Office Action Summary	Application No. 10/518,205	Applicant(s) NEERINCX ET AL.	
	Examiner ROBERT K. NICHOLS II	Art Unit 3754

DETAILED ACTION

Claims 1-3, 7-10, 12, 13, 16, 18-20 and 23 are rejected under 35 U.S.C. 102(b) as being anticipated by Andris (US 5,205,441).

Portion of Figure 3

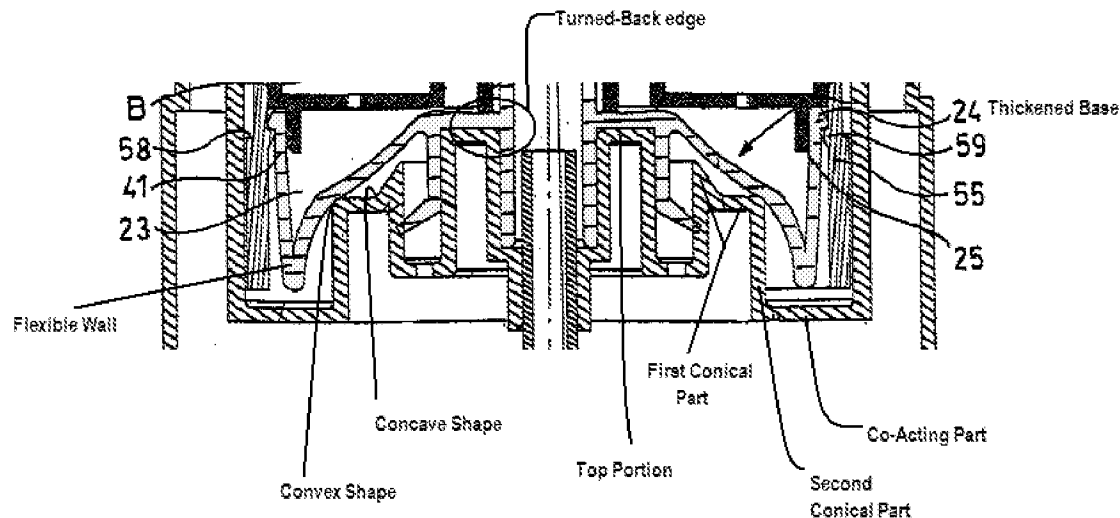
Regarding claims 1, 7 and 20, Bistolfi discloses a pump assembly including; a bellows part having a flexible wall 22, a thickened base 24 at one end of the flexible wall; a turned-back edge (portion of fig. 3) at an opposite end of the flexible wall 22; a cylindrical pressure valve 63 adjacent the thickened base 24 at one end of the flexible wall (fig. 5); and a suction valve 46 encircled by the turned-back edge; a co-acting part 8

including a top portion and an outer wall (see portion of fig. 3); wherein the turned-back edge of the bellows part rests on the top portion of the co-acting part 8 and the bellows part co-operates with the co-acting part 8 (see figure 2 and portion of figure 3).

Regarding claim 22, Bistolfi discloses the rolling and unrolling of the bellows part over at least a portion of the co-acting part 8 (see figure 3).

Regarding claims 6, 24 and 25, Bistolfi discloses the outer wall of the co-acting part 8 being conical having first and second conical parts (portion of figure 3); the first conical part includes an angle of inclination which is different than an angle of inclination of the second conical part (see portion of figure 3).

Regarding claims 26 and 27, Bistolfi discloses the first conical part includes a concave shape and convex shape (see portion of figure 3 above).
